This document provides responses to the traffic and transport related matters raised by the Department of Planning, Housing and Infrastructure (DPHI) and Bayside Council (Council) in their submissions to the site 68-80 Beauchamp Road, Hillsdale (SSD –83256478).

**Table 1: Responses to DPHI comments**

**Table 2: Responses to Council comments**

## **Appendix A: Swept Path Diagrams**

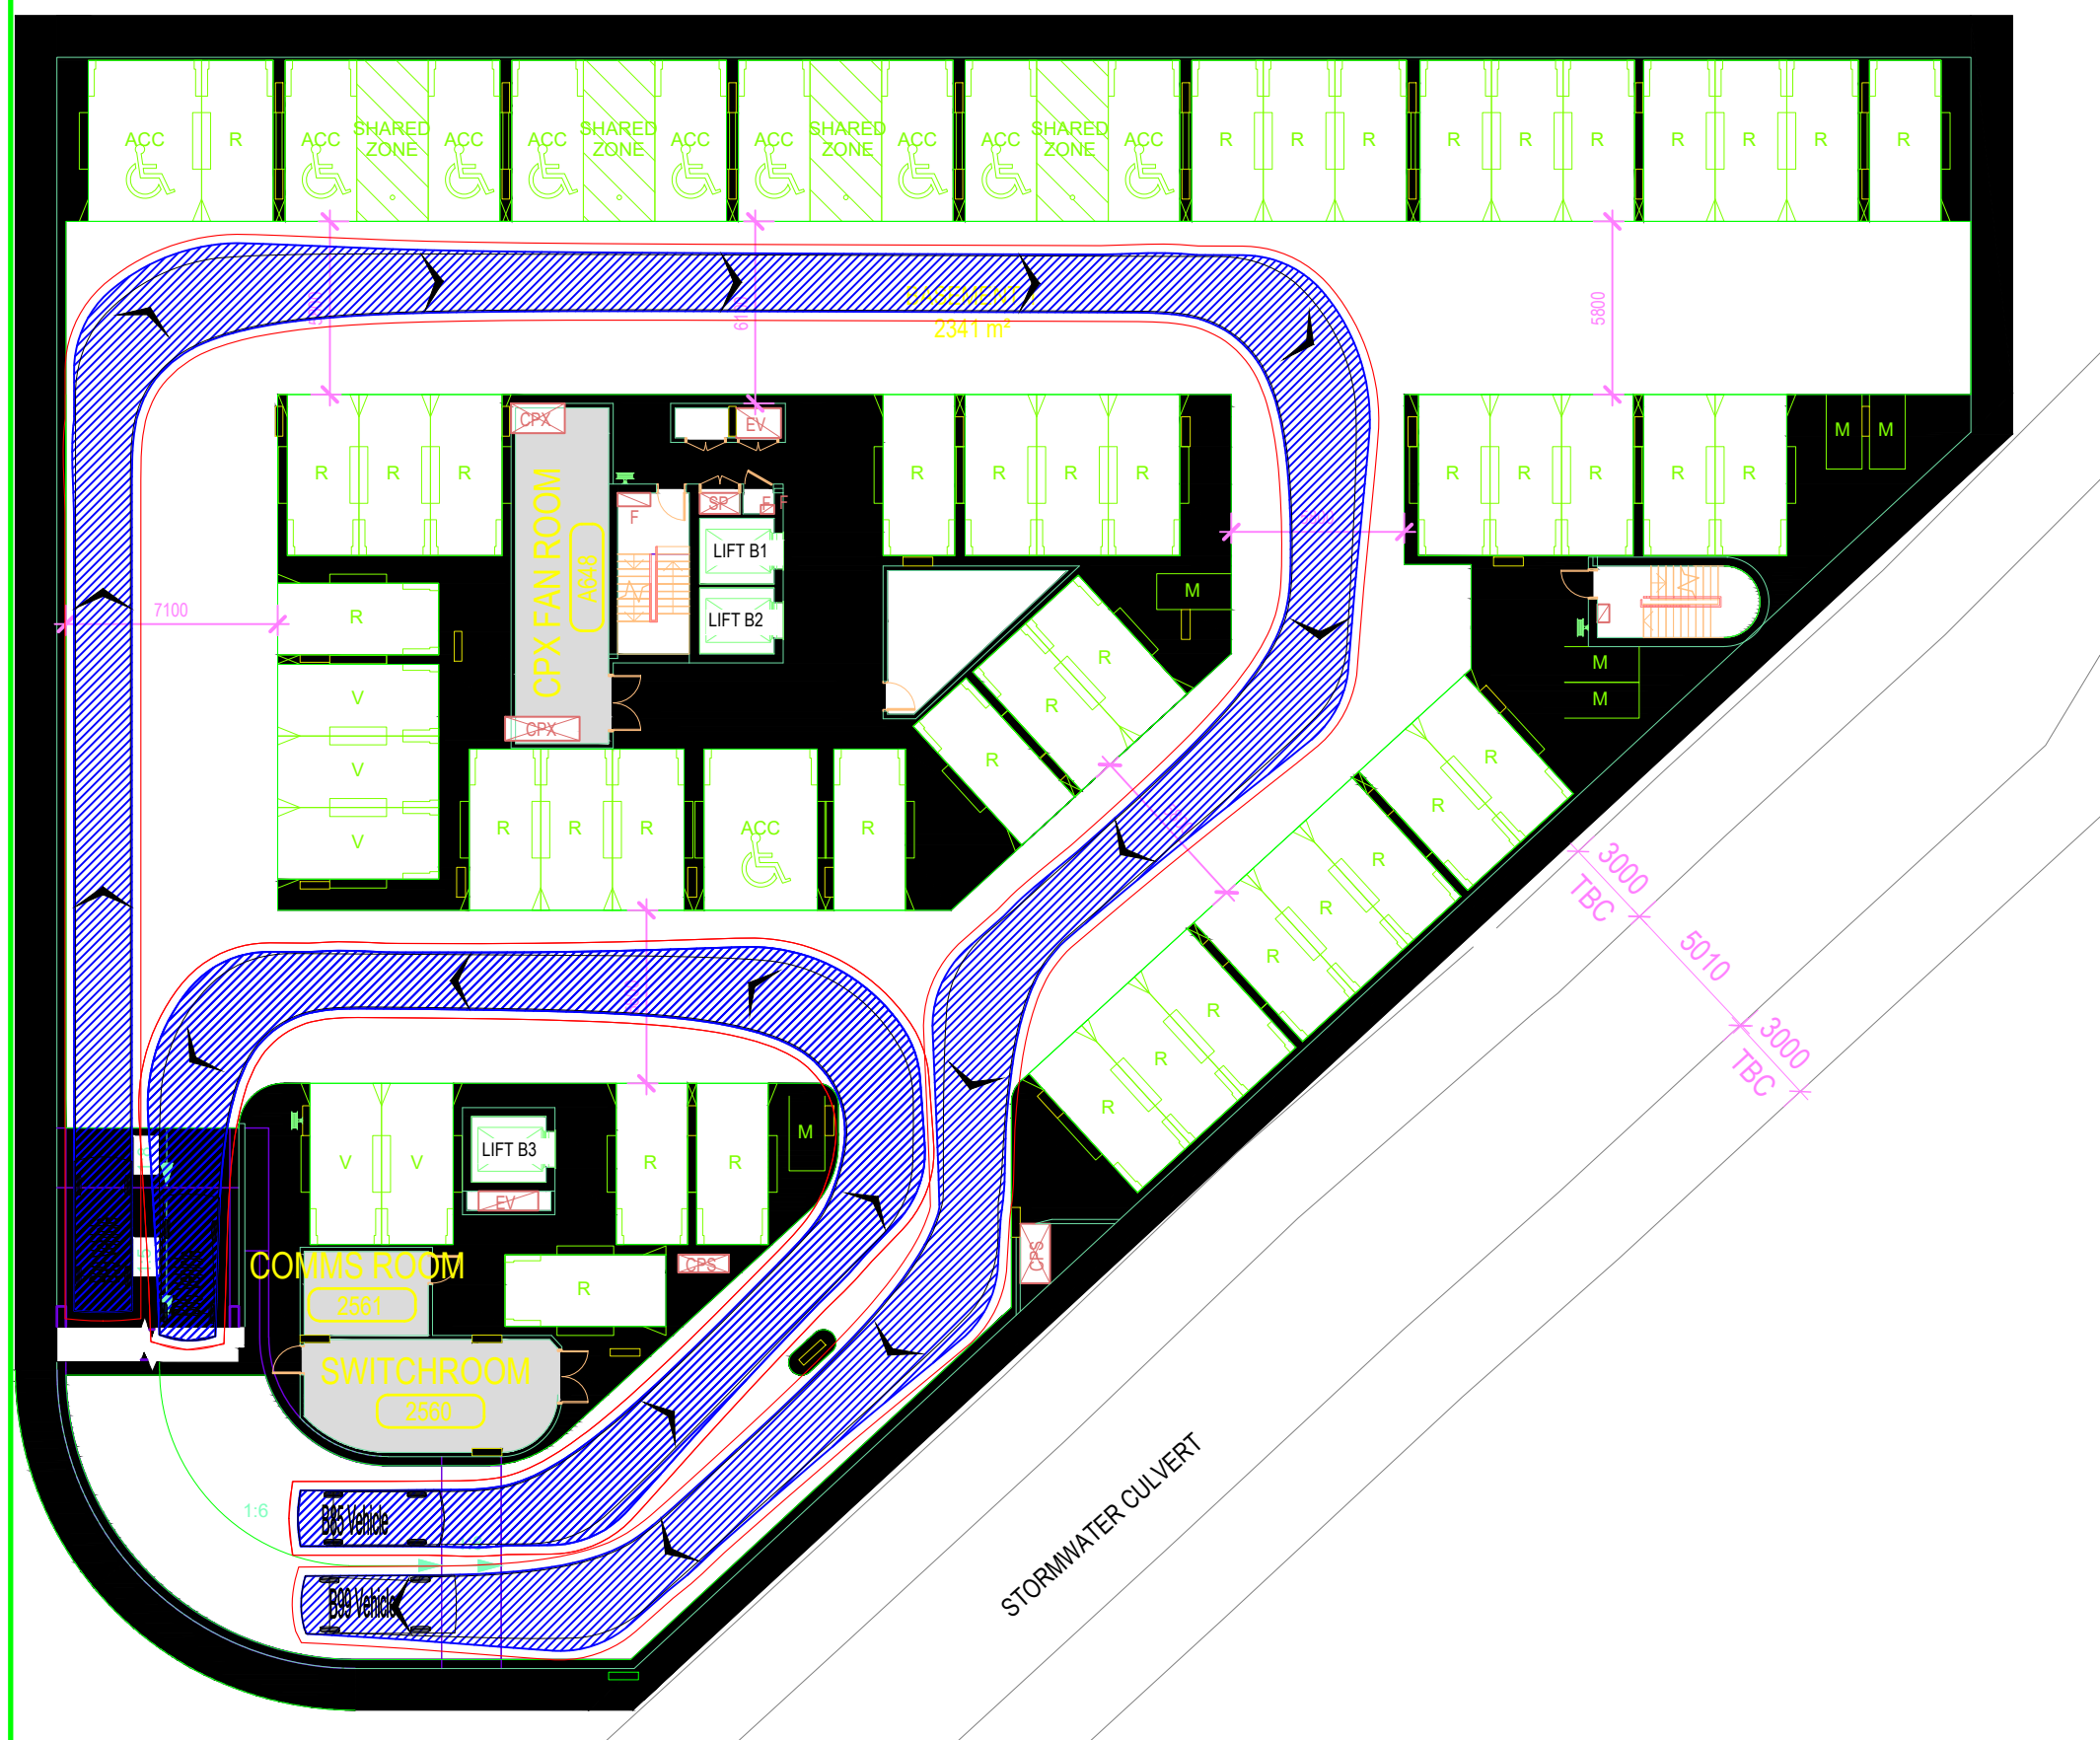
<p>Provide swept paths for all basement areas.</p>	<p>Swept paths have been provided as per Appendix A of this document. Basement swept paths will be the subject of further design resolution during the detailed design phase of the project, with sign off from a suitably qualified engineer required to confirm the layout conforms with the requirements of AS2890.1 prior to the issue of a Construction Certificate. It would be expected this requirement would be reinforced through a suitably worded consent condition.</p>

# SITE LAYOUT

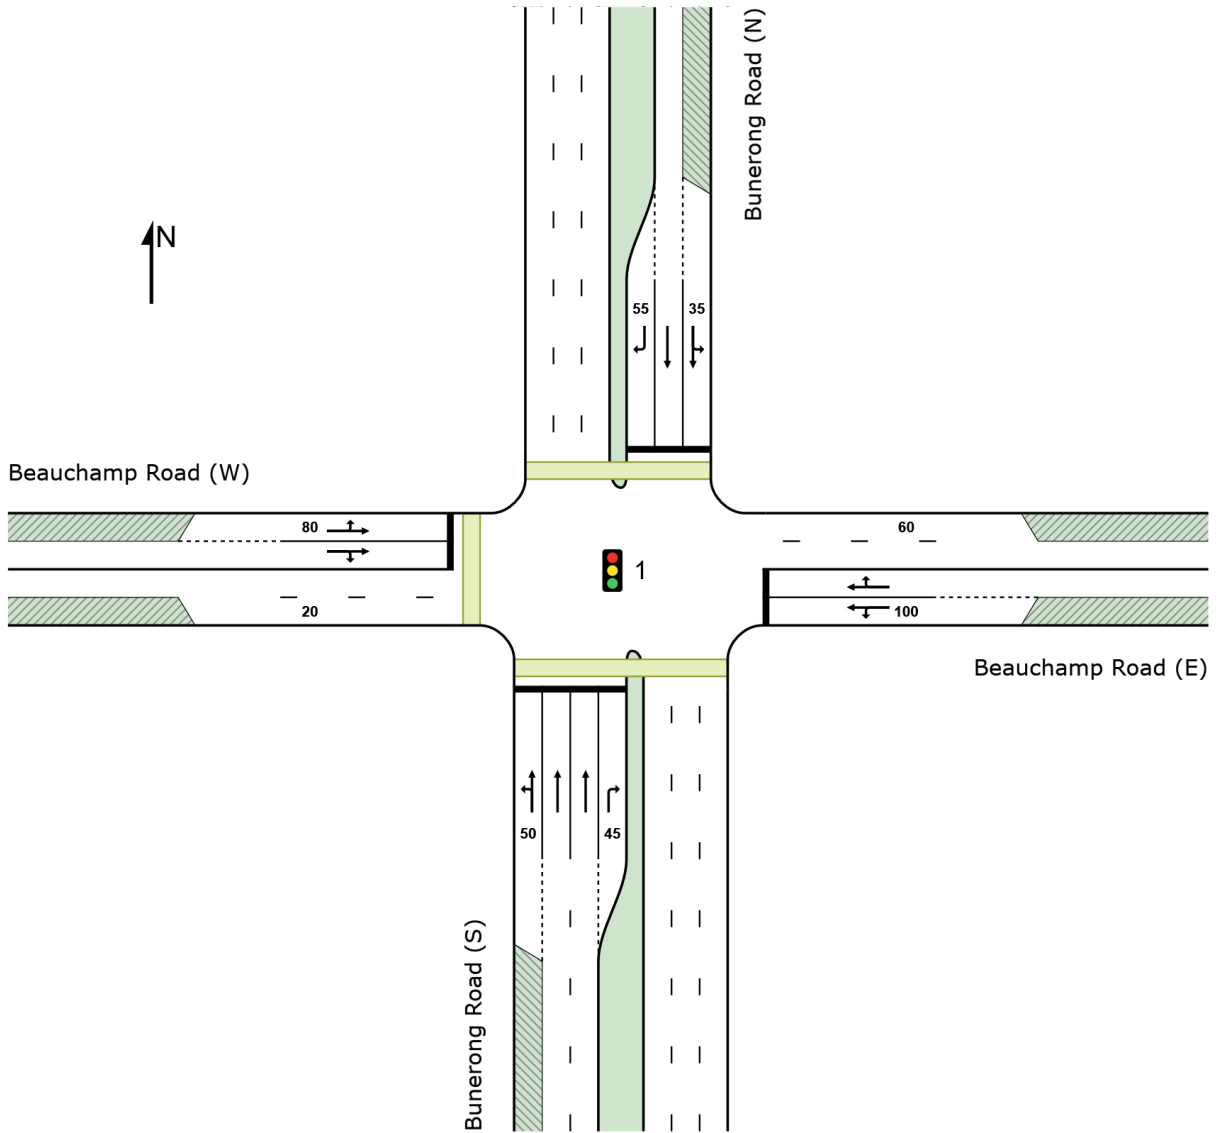
Council Comment	JMT Consulting Response
<p>SIDRA modelling:</p> <ul style="list-style-type: none"> <li>The SIDRA modelling presented in the appendix of the traffic report needs to be revised to be accompanied by Intersection Layouts and Phasing Summary.</li> </ul>	<p>Additional SIDRA modelling outputs are provided as Appendix B of this document as requested by Council.</p>
<p>Bicycle and motorcycle parking:</p> <ul style="list-style-type: none"> <li>The development shall be revised to provide bicycle and motorcycle parking as per Bayside DCP, Section 3.5.4.</li> <li>The number of bicycle and motorcycle spaces shall be clearly shown on the architectural plans.</li> <li>The architectural plans do not include an appropriate area for resident and visitor bicycle parking. Council requires a secure room (Security Level B) for resident bicycle parking designed as per AS2890.3.</li> </ul>	<p>The Bayside DCP outlines minimum bicycle parking requirements for residential developments - to be provided at the rate of 1 space for every dwelling.</p> <p>192 bicycle parking spaces for residents are indicated on the architectural plans, including 14 at ground level for the use of visitors to the site. The remaining 178 spaces are provided in storage areas within each residential level of the buildings. This is consistent with a Security Level A facility as described in AS2890.3 and therefore conforms with relevant Australian Standards.</p>
